RE: **Drive Thru Restaurant**  
**700 Coors Blvd NW**  
**Grading Plan Stamp Date: 5/15/20**  
**Hydrology File: J11D039**

RE: 700 Coors Blvd NW Albuquerque, NM 87105  
**Hydrology File No. J11D039**

**DUTCH BROS COFFEE**

GD1.1

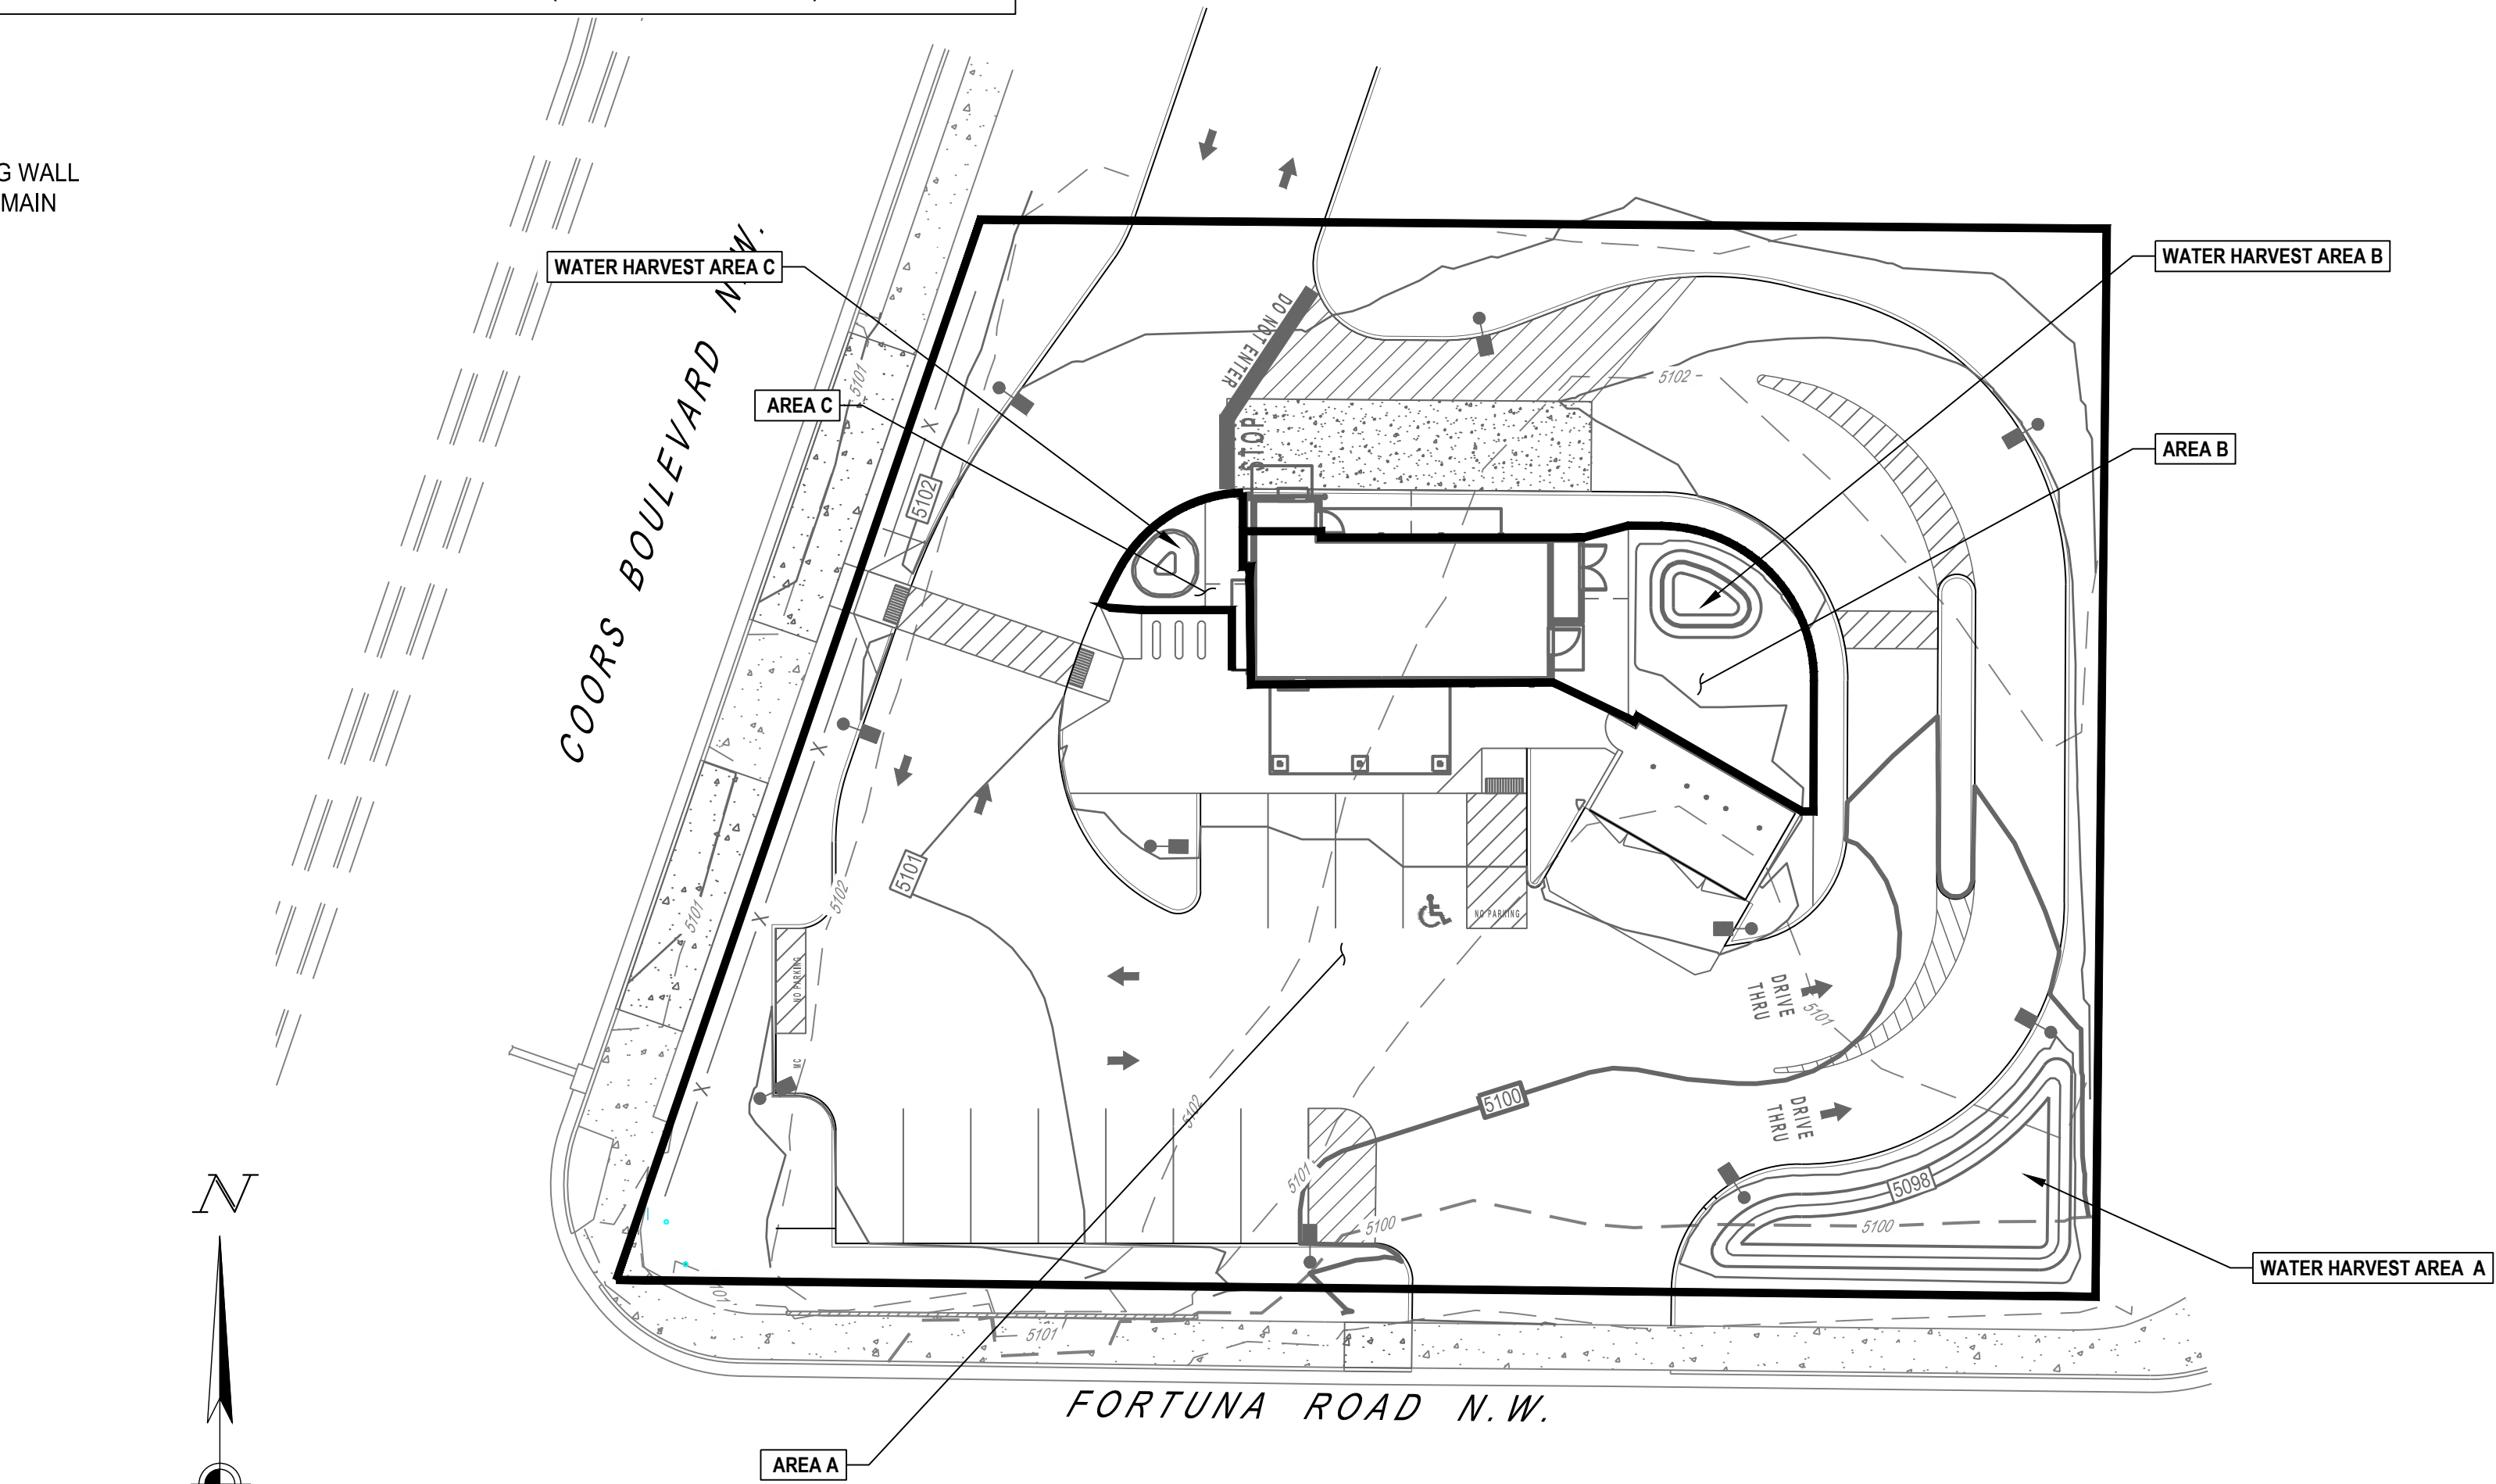
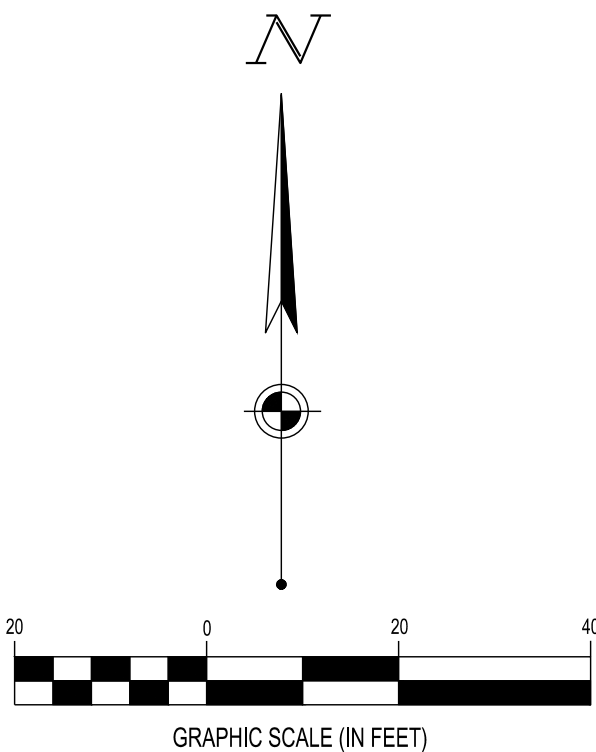
3. Provide hydrologic calculations per the DPM, Ch 22.2.A for the 100-yr storm. Also, a brief narrative describing the project and existing/proposed grading and drainage is recommended (DPM Ch 22.7: *Grading Plan Checklist*).

4. Provide outfalls for both ponds, sized for the 100-yr peak inflow. Include supporting hydraulic calculations as needed.

**Response: This has been added to the plans on Sheet GD1.1.**

**Response: The ponds are designed as retention ponds to provide rainwater harvesting. Hydraulic calculations are provided on Sheet GD1.1.**
